CITY OF TEMPE DEVELOPMENT REVIEW COMMISSION

Meeting Date: 8/8/2017 Agenda Item: 4

<u>ACTION</u>: Request approval of a Use Permit to allow vehicle sales (indoor) and a Development Plan Review for a new industrial building consisting of 161,168 square-feet of above and below ground warehouse and 13,106 square-feet of two story office for PRECISION FLEET SERVICES (PL160420), located at 360 South Smith Road. The applicant is Artec Designs.

→ LANDSCAPE PLAN

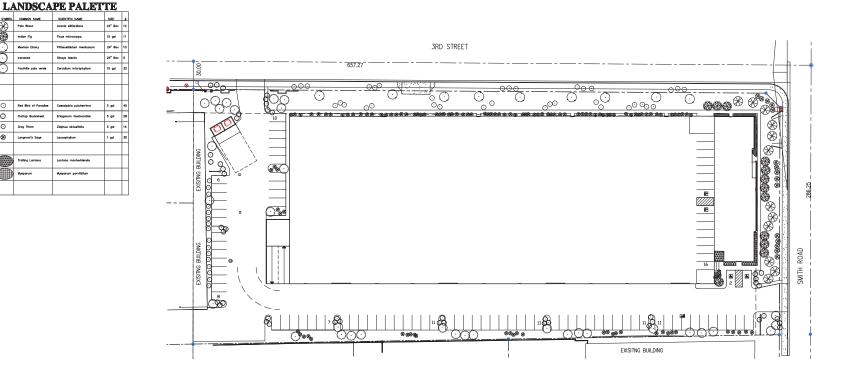
- Staff recommended fifty (50) percent vegetative ground cover throughout the site. The applicant provided fifty (50) percent coverage along Smith Road and but not as much elsewhere.
- Staff informed the applicant that palm trees are not considered street trees. The applicant replaced all palm species with shade trees.
- Staff requested a landscape plan that complies with the Code's development standards in regards to parking facilities. After several revisions, the landscape plan does not provide all required trees and ground cover in each parking lot landscape island.

Approximately 32,057 square feet of landscape area will be provided, equating to landscape coverage of 18.9%. Forty-three (43) street trees will be provided; twenty-two (22) on 3rd Street, one (1) on the street corner, and twenty (20) on Smith Road. Parking lot landscape islands are provided at the end of each parking row, and at minimum, one per twelve (12) parking spaces. Although the landscape plan does not provide the required tree and ground cover in each island, the Development Plan Review will condition that each island complies with the landscape development standards.

- 22. Each parking lot landscape island shall include, at the time of installation, a minimum of one (1) tree with a minimum caliper of one and one-half (1 ½) inches and five (5) ground covers of one (1) gallon size for each parking space length.
